Town of Windsor
Class I Trails Study 1st Community Workshop
Meeting Notes
September 21, 2017

Meeting Notes

Northwest:

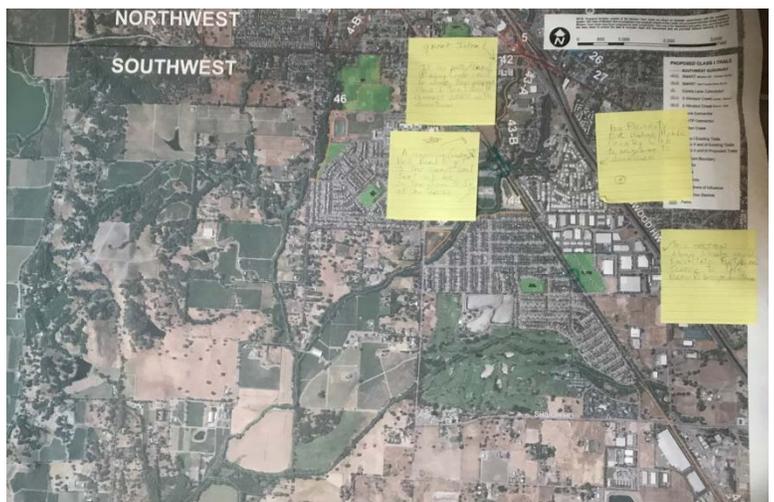
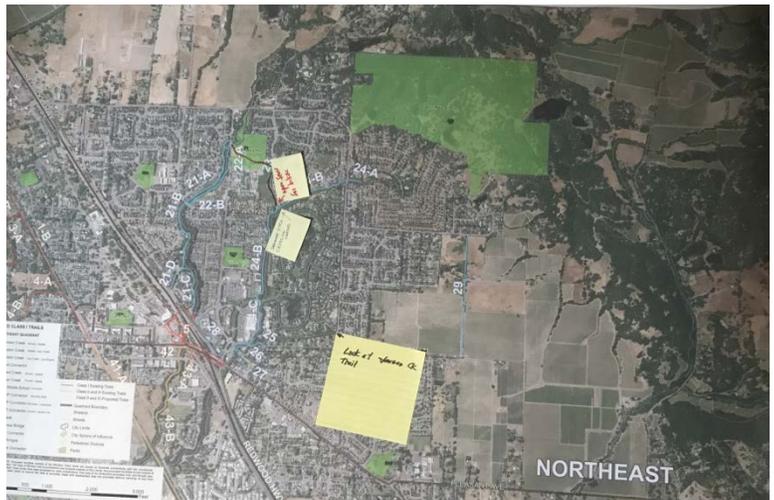
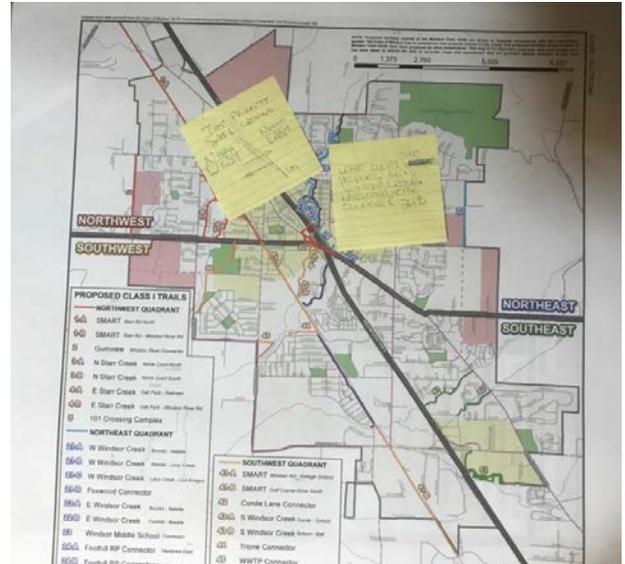
- (Improve) Windsor River road Cali Calmecac to Town Green.
- You guys should make a trails app for bikes and walking trails.

Southwest:

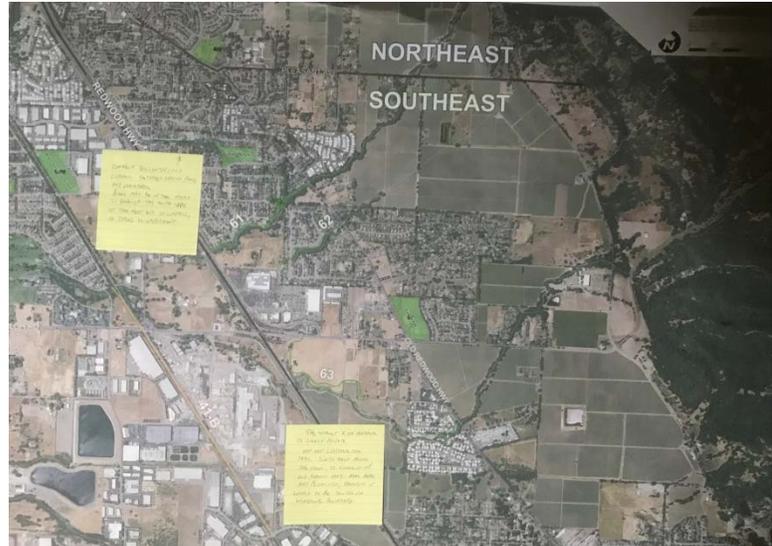
- (43A) Great idea! If a path/trail along Conde

- can't be done, this proposed Class I trail would connect WMCC with downtown.
- A big priority is for Windsor Mobile Country Club to be able to walk downtown.
- A connection (under Bell Road) to get to the SMART Trail that will be on the other side of the tracks.
- This section along Conde (north of Mitchell) would facilitate foot/bike traffic to the brew pub and Downtown.
